Technical Service Bulletin

**INSUFFICIENT HEATER PERFORMANCE UNDER -4 °F (-20 °C)
OR COLDER ENVIRONMENT**

Bulletin No.: 07-001/23

2022 MX-30

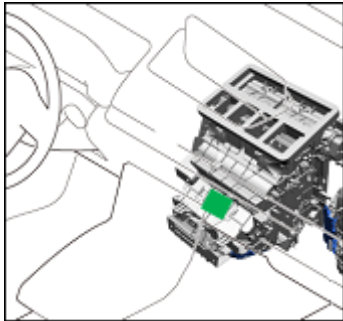
Some customers may complain about insufficient heater performance under -4 °F (-20 °C) or colder environment. This is caused when the air conditioner is set to the defroster mode, cold air bypasses around the PTC heater and the warmed air at the PTC heater is cooled down by the cold air around it. This results in insufficient heater performance. To eliminate this concern, the cold air around the PTC heater has been reduced and the control software of the heat pump control unit has been modified to increase the output temperature of the PTC heater.

1. Verify the customer concern.
2. Add a heat resistant gasket to the top of the PTC heater according to the procedure below.

Label on heater unit

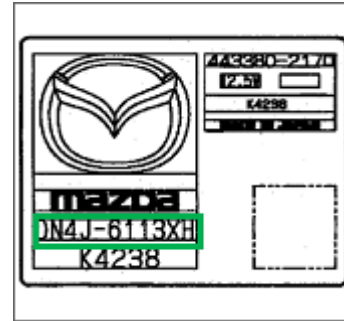
*If concerned VIN is around the one in parentheses in the table, confirm the part number on the label attached to the heater unit.

VIN	Part Number	
	Before modified (to add gasket)	Modified (Not to add gasket)
Around 101332	DN4J-6113XG	DN4J-6113XH

Heat resistant gasket installation procedure

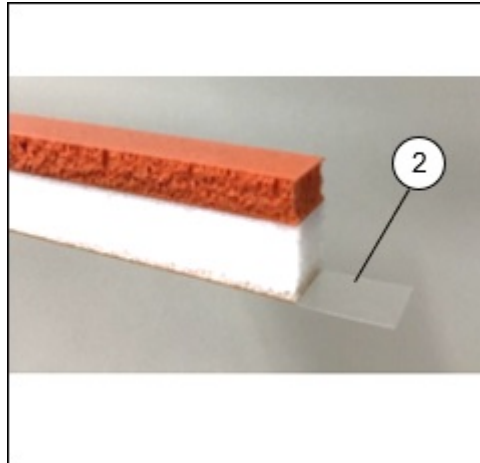
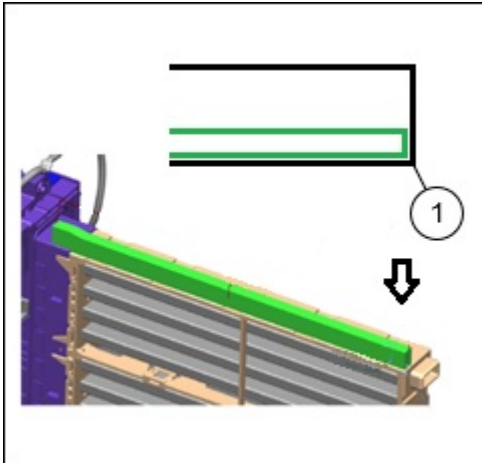
1. Remove the PTC heater according to the workshop manual (POSITIVE TEMPERATURE COEFFICIENT (PTC) HEATER REMOVAL/INSTALLATION).
2. Adhere the gasket to the top of the PTC heater.
 - Starting at the lower right corner (1) in the top view, align the gasket along with the frame.
 - Keep the gasket within the frame.
 - Keep the gap between the gasket and the frame 1.5 mm or less.
 - When removing the separator (2), take care not to remove the orange double sided tape from the white foam rubber.

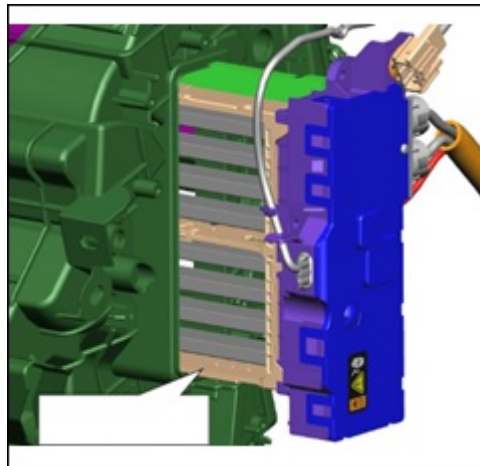
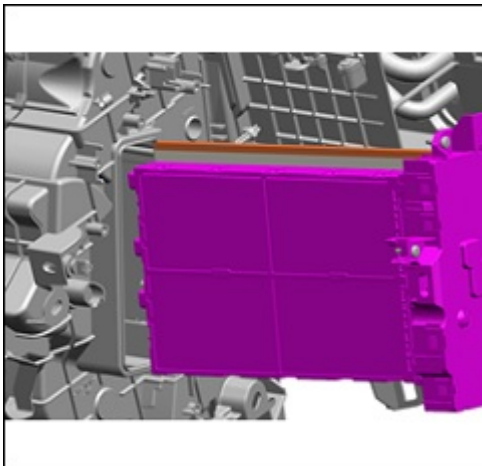
NOTE: To prevent damage on the added gasket, take the following precautions:

- At first, insert the PTC heater diagonally.
- Insert the PTC heater so that the bottom of it moves along the bottom of the opening.
